## ADDENDUM #ONE

**Date:** July 8, 2025  
**Project:** Ball State University Cooper Science Underground Detention  
**Schneider Job:** 17413  
**Ball State University Project Number:** 2025 – 017.00 CS  
**Distribute To:** All Bidders of record, Ball State University, and Schneider Geomatics

BALL STATE UNIVERSITY  
COOPER SCIENCE DETENTION

DATE: 06/17/2025	PROJECT NO.: 2520070
DRAWN BY: MRM	CHECKED BY: MRM
SHEET TITLE: SITE DEVELOPMENT PLAN	
DRAWING FILE: T:\25K\2520070\CAD\2520070-C101.DWG	
XREF(S):	
SHEET NO.: C101

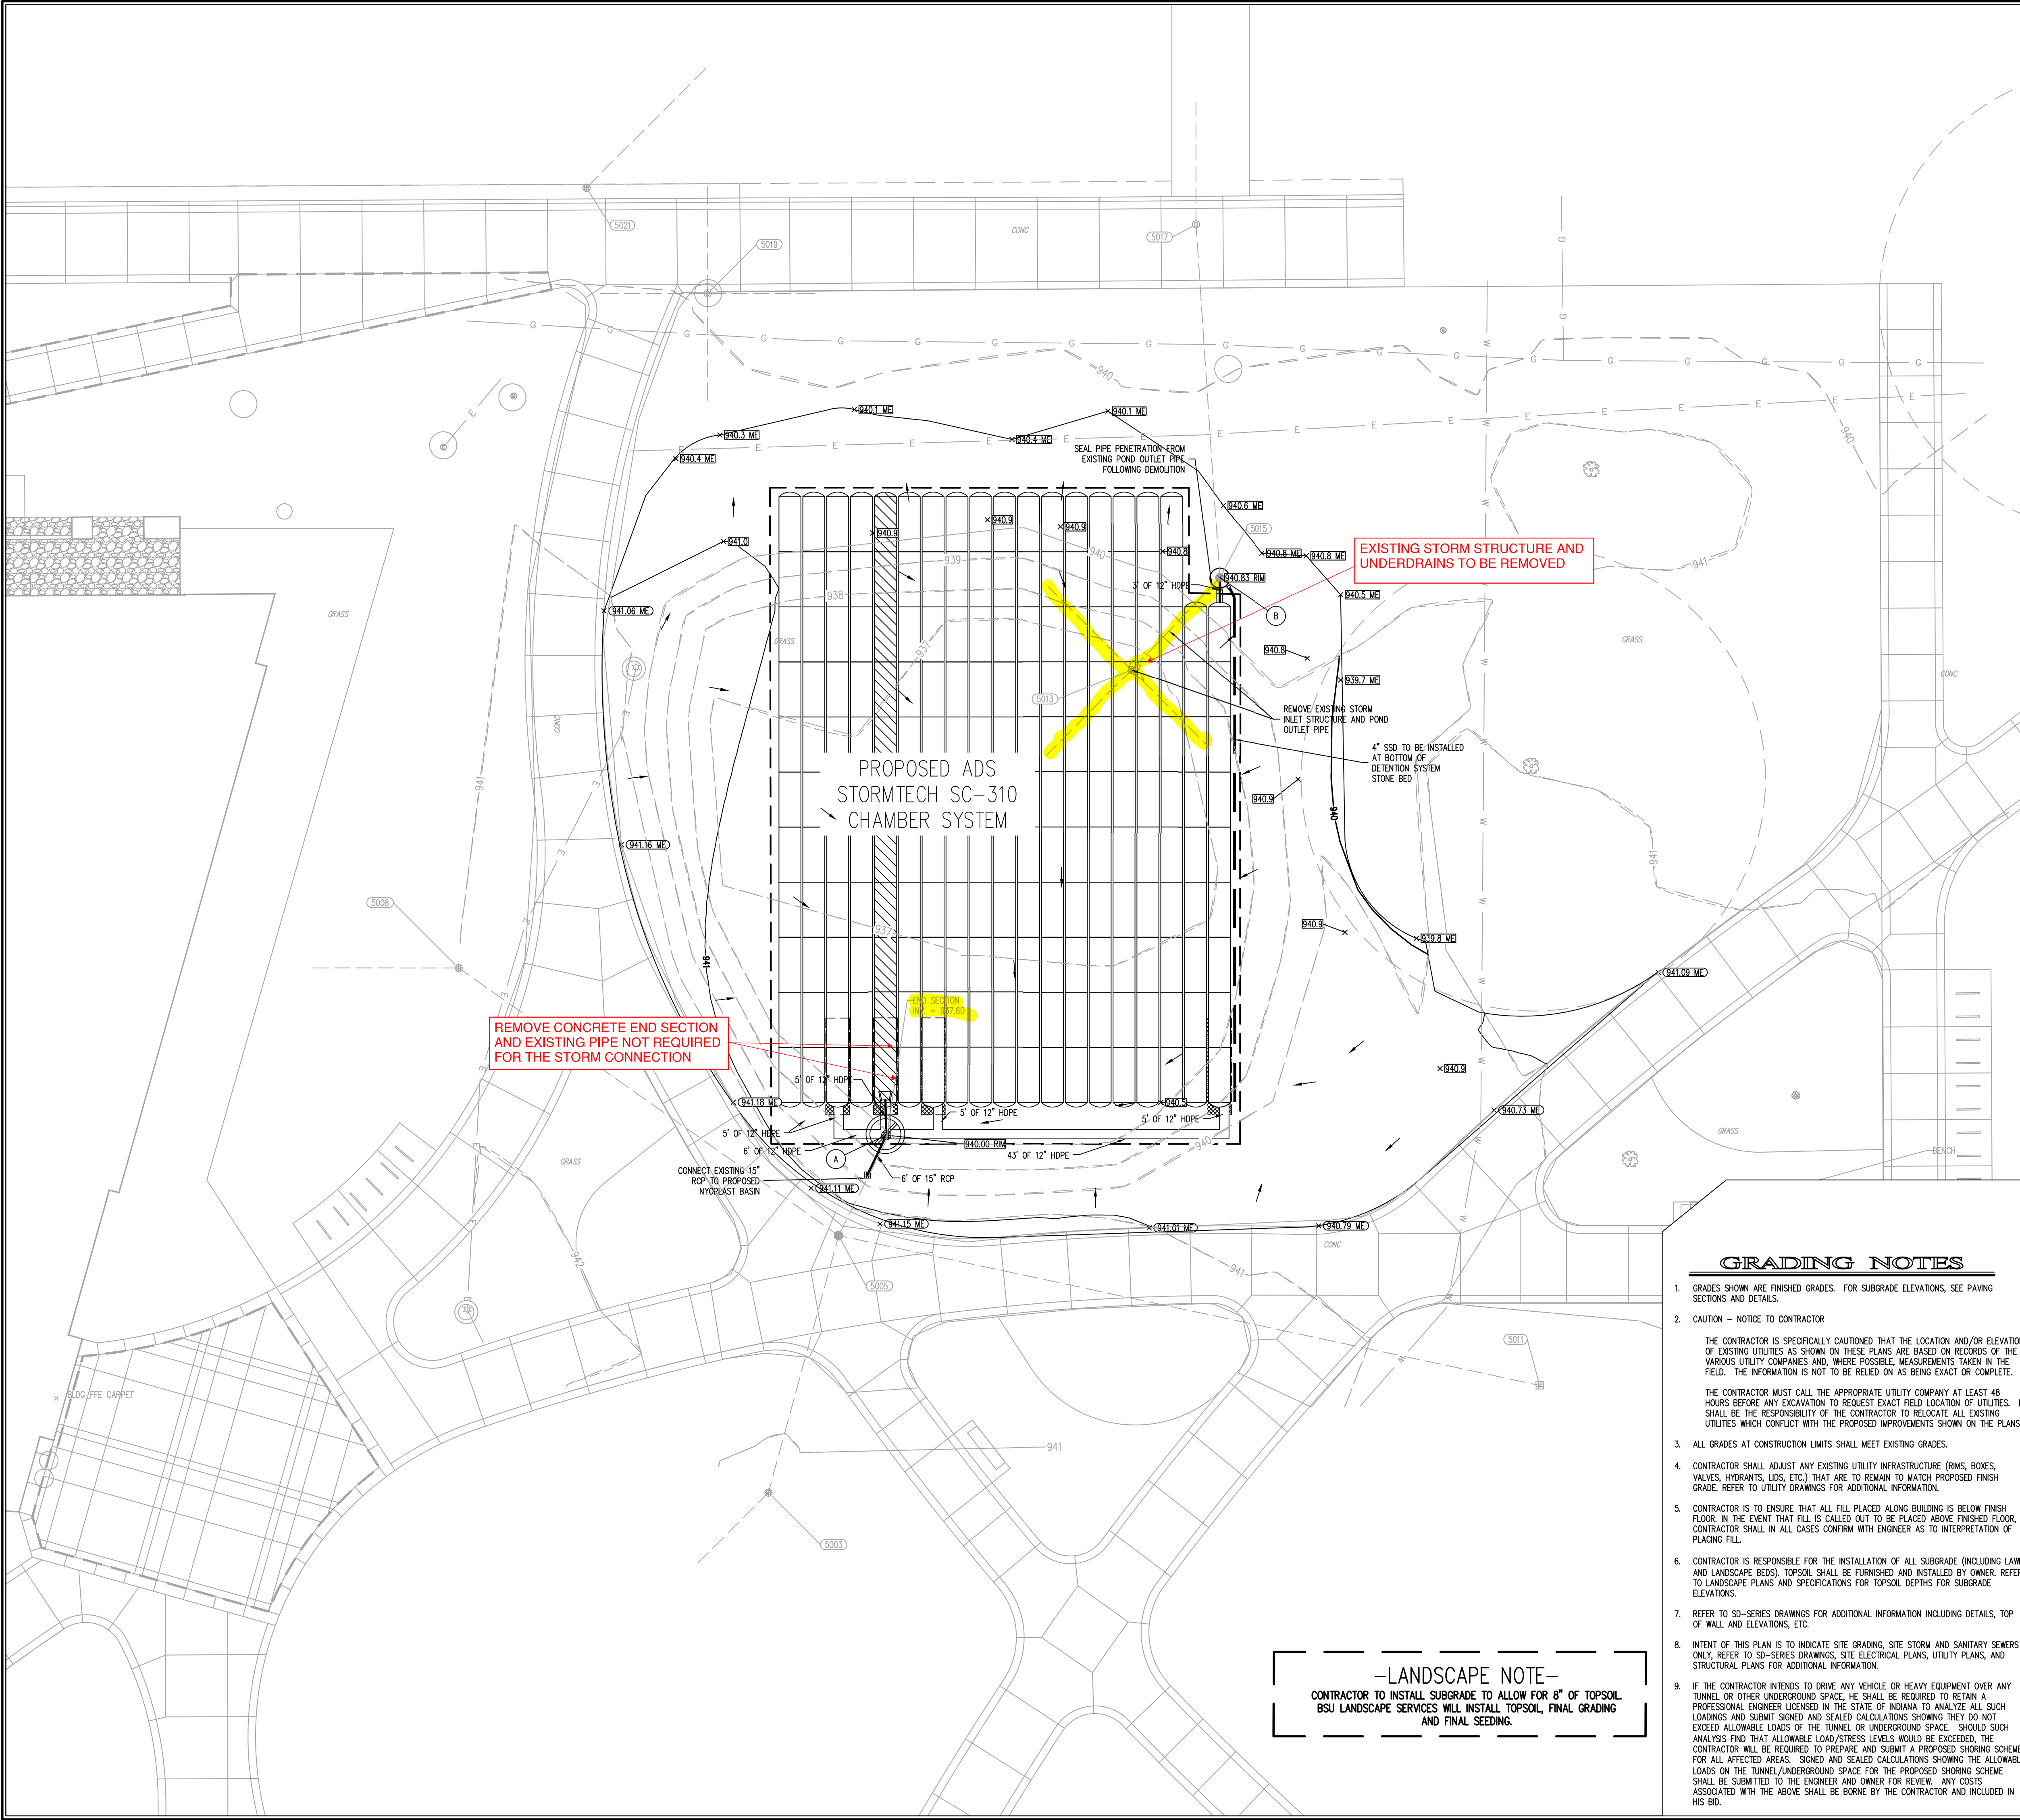
DRAWINGS		
Item	Sheet No.	DESCRIPTION
1	C101	ADDITIONAL INFORMATION ADDED ON THE REMOVAL OF EXISTING STORM STRUCTURES AND PIPE MATERIAL.
2		
3		
4
